# You Said, We Did

BURY ATF  
FISHPOOL AND  
PIMHOLE ACTIVE  
NEIGHBOURHOOD

## BURY ATF OVERVIEW PLAN

60660026-ACM-000-ZZ-DR-TR-0042

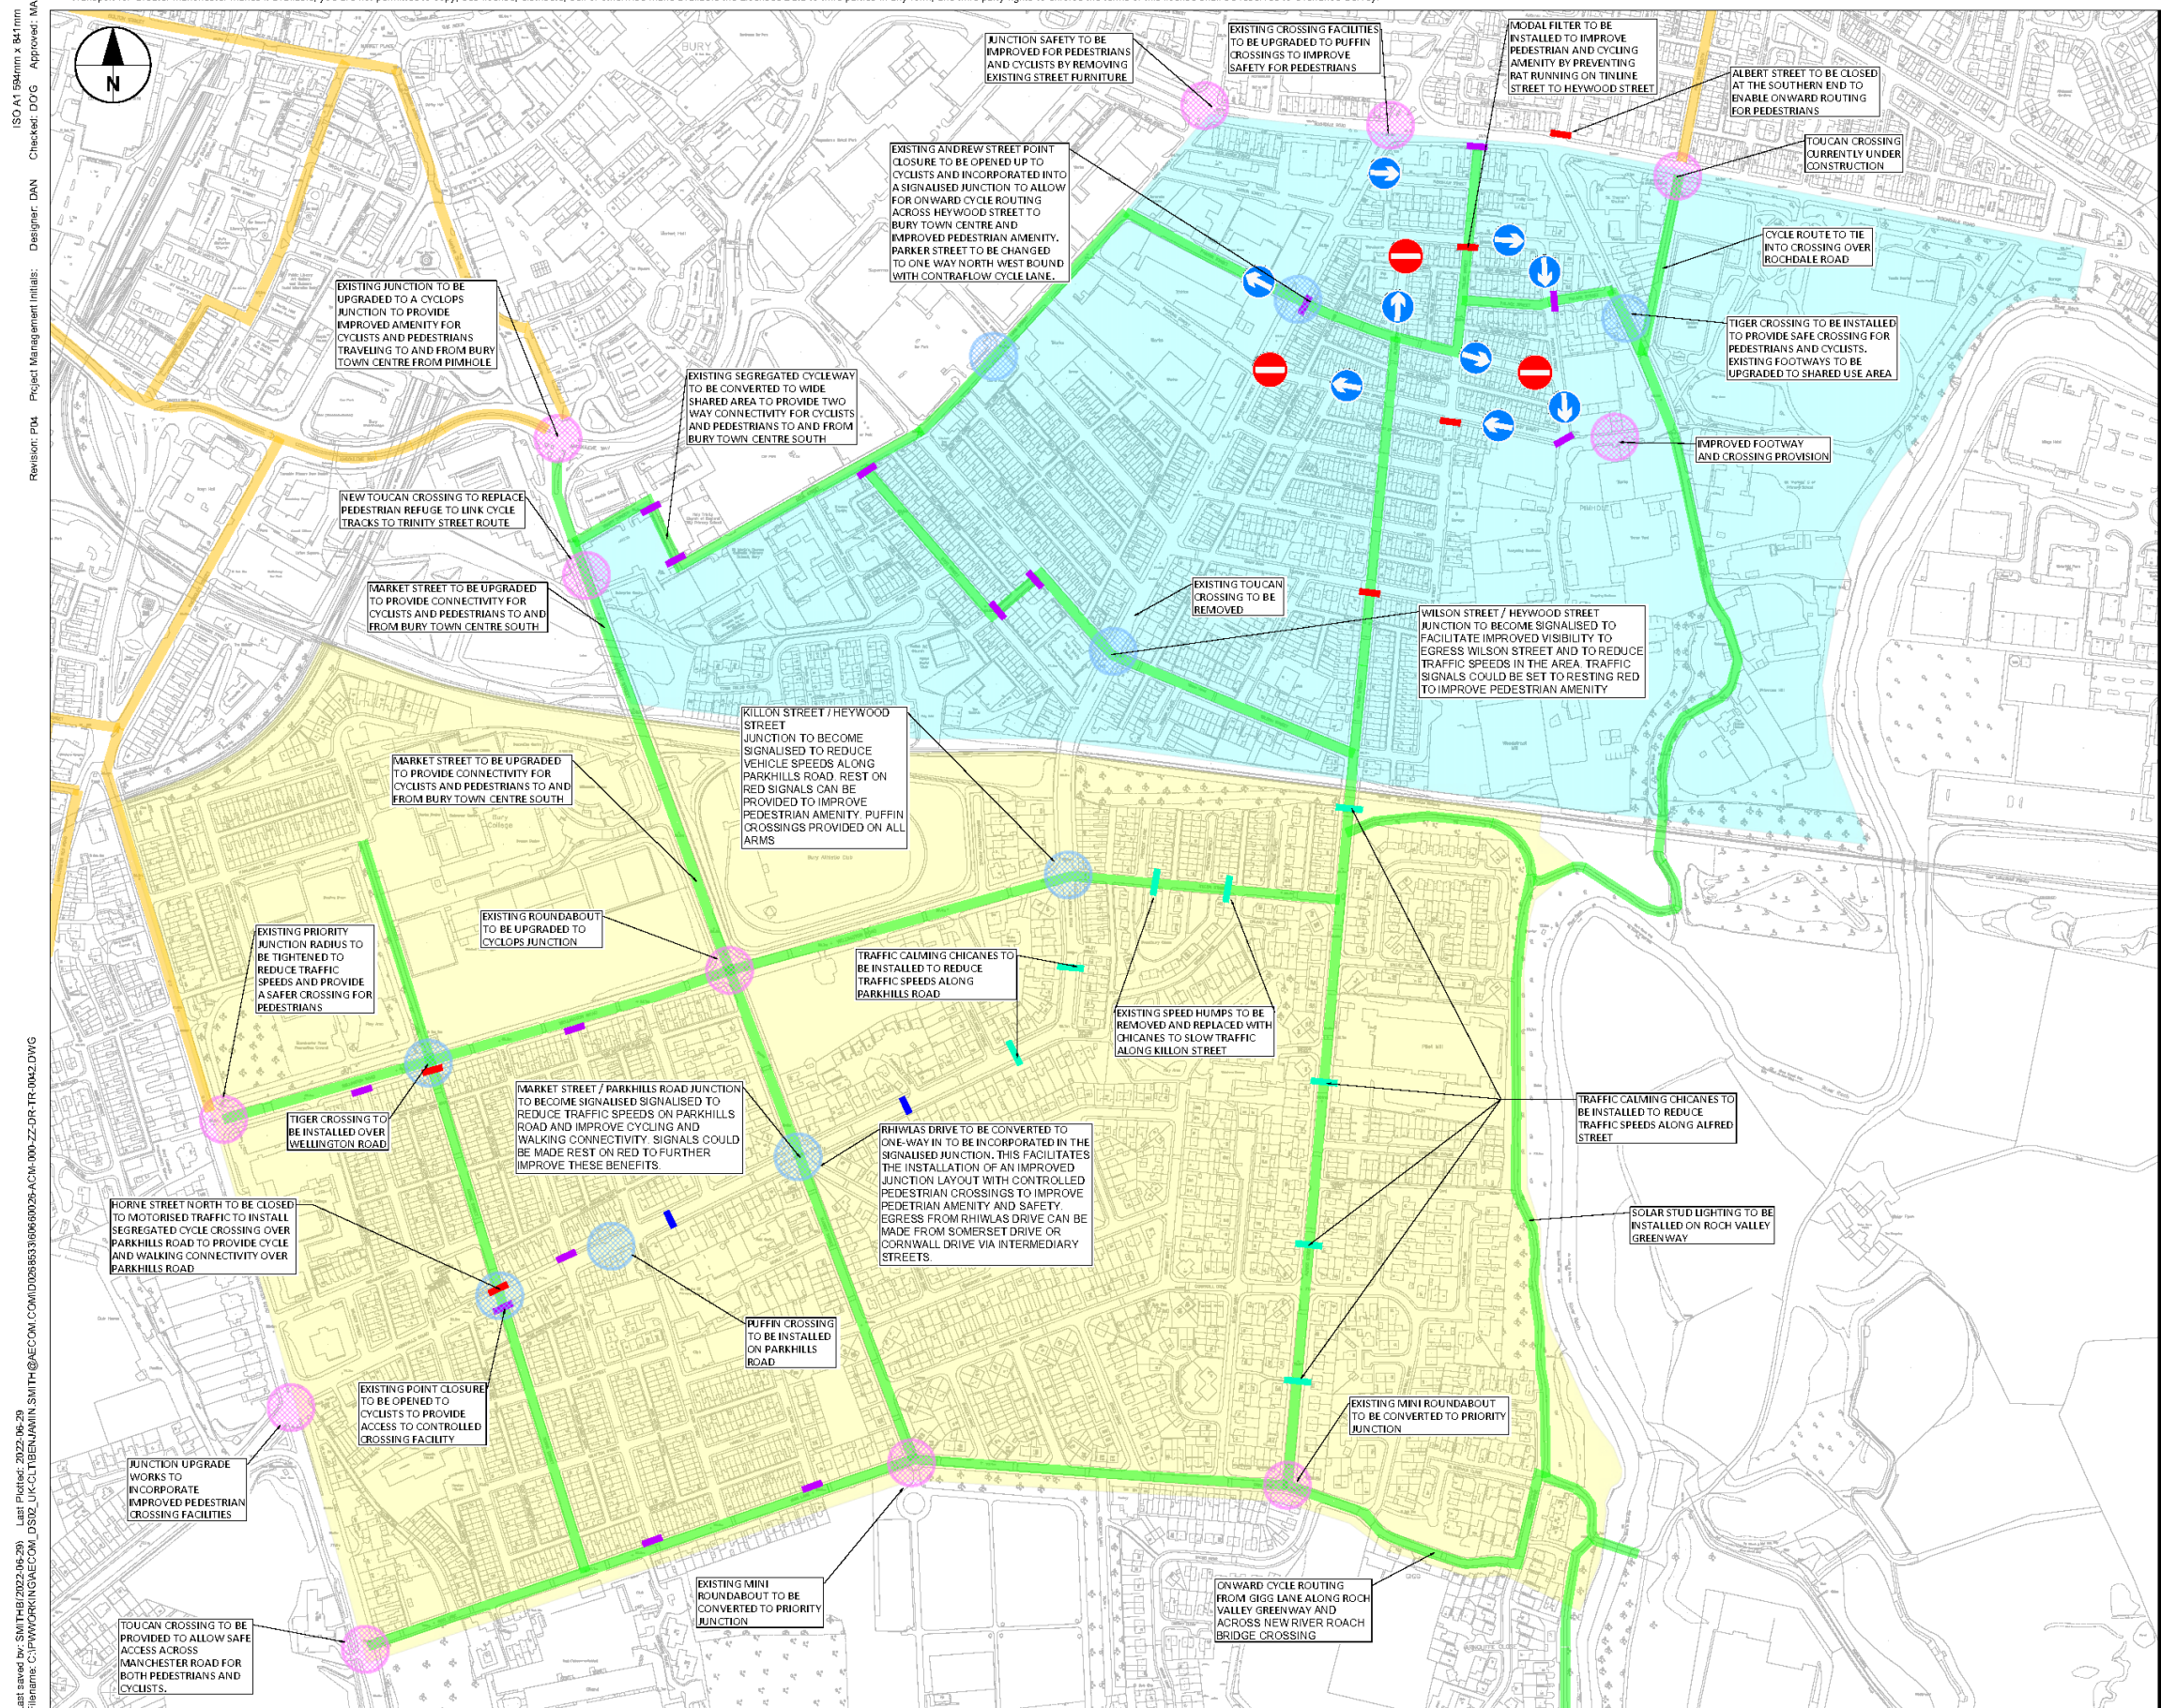
You Said	We Did
You said there should be a pedestrian crossing over Parkhills Road at Nelson Street instead of Horne Street due to the location of the primary school.	The Horne Street crossing location was selected due to the north-south route formed from Gigg Lane to Wellington Road, however it is recognised that a crossing at Nelson Street would be beneficial for accessing the primary school. An additional crossing is therefore proposed close to Nelson Street in the updated design.
You said that traffic should be directed to Wellington Road instead of Parkhills Road as it has fewer houses and is more suitable as a through route.	It is agreed that Wellington Road has the capacity to take through traffic, however the junction of Manchester Road/Wellington Road does not have the capacity for Wellington Road to be used as the primary route. The current junction of Manchester Road/Parkhills Road has a high capacity and provides a direct route

from Radcliffe Road. It is therefore not considered feasible to redirect traffic.
You said we should install additional traffic calming on Parkhills Road	Many consultation feedback comments raised concerns over speeding on Parkhills Road. The updated design has therefore included improvements to traffic calming on Parkhills Road.
You said the proposed designs were blocking routes used by residents.	The proposed filters have been placed ensuring viable alternate routes are accessible. Although this will cause some increase in journey length and time, this should be small compared to overall journey times.
You said you were concerned that the proposed traffic calming chicanes on Parkhills Road were dangerous.	The design adopted for the chicane design is a standard detail that has been used across Greater Manchester and is not associated with an increase in road traffic accidents. Before construction, all designs will undergo a Road Safety Audit by a qualified road safety engineer to identify potential hazards to be addressed.

You said we should improve the traffic calming on Gigg Lane.	Gigg Lane has not been identified through the public engagement and consultation as a particular issue for speeding vehicles. It is therefore not considered necessary to improve the traffic calming on Gigg Lane.
You said Killon Street was not a suitable road for the through traffic that would be experienced due to the Alfred Street bridge filter point.	The intention is that the scheme will reduce the number of vehicles using Alfred Street and therefore the increase in traffic using Killon Street would not be large. It is understood that the capacity of the road is low and not suitable as a primary route, this is one reason the filter on the Alfred Street bridge has been removed in the updated design.
You said you were concerned that the Alfred Street bridge filter point would attract antisocial behaviour and be a risk to residents.	It is agreed that there is a risk that the Alfred Street bridge filter point will attract antisocial behaviour – this is one reason the filter has been removed from the updated design.

You said you were concerned that the Alfred Street bridge filter point would restrict HGV access to Pilot Mill.	The Alfred Street filter point would restrict HGV access to Pilot Mill from Wilson Street, however access would be maintained via Gigg Lane. The filter point has, however, been removed from the updated design.
You said you would like improved traffic calming on Alfred Street.	With the updated design removing the Alfred Street bridge filter point the issue of vehicles speeding on Alfred Street is not addressed, therefore the updated design includes improvements to the traffic calming.
You said we should make the Alfred Street bridge one-way.	There is a risk that making Alfred Street one way at the bridge would make speeding worse as there is no opposing traffic to account for.

You Said	We Did
You said the Wilson Street filter point restricted HGV access to the businesses on James Street.	It is acknowledged that the consultation design did not account for HGV access to James Street. The updated design removes the Wilson Street filter to maintain access to James Street.
You said we should make Parker Street one-way in from Heywood Street and make the proposed traffic lights request only.	Making Parker Street one-way in does simplify the junction layout with Heywood Road and therefore this has been adopted for the updated design.
You said that the new one-way restrictions on Ormrod Road make the routeing for residents on Kershaw Street very long to get to Heywood Road and onwards.	It is recognised that the one-way section of Ormrod Road makes the routing from Kershaw Street to Heywood Road overly long and makes access to the business on Heywood Road easier. The updated design therefore removes the proposed section of one-way on Ormrod Street.

You said you would like traffic calming on Kershaw Street	Due to the low traffic flows on Kershaw Street, traffic calming in this location is not considered a priority.

As a result of the comments received during the public consultation, the changes listed below are proposed to the design for the ATF and MCF schemes. The revised design layout is shown in Appendix A.

- New controlled pedestrian crossing over Parkhills Road at Nelson Street
- Additional traffic calming on Parkhills Road
- Removal of Alfred Street Bridge filter point
- Improved traffic calming on Alfred Street
- Removal of Wilson Street/Alfred Street filter point
- Make Parker Street one-way in with contraflow cycle lane
- Remove new section of one-way on Kershaw Street at Heywood Street

- Maintaining the current number of lanes through the Manchester Road / Parkhills Road junction
- Change alignment of northern crossing on the Manchester Road / Parkhills Road junction to make more direct
- Widen footways on Manchester Road / Parkhills Road junction where possible
- Provide raised table crossing over Wellington Road at junction with Manchester Road
- Suspend parking on approach to Gigg Lane / Market Street to improve visibility
- Change Gigg Lane / Alfred Street mini-roundabout to priority junction
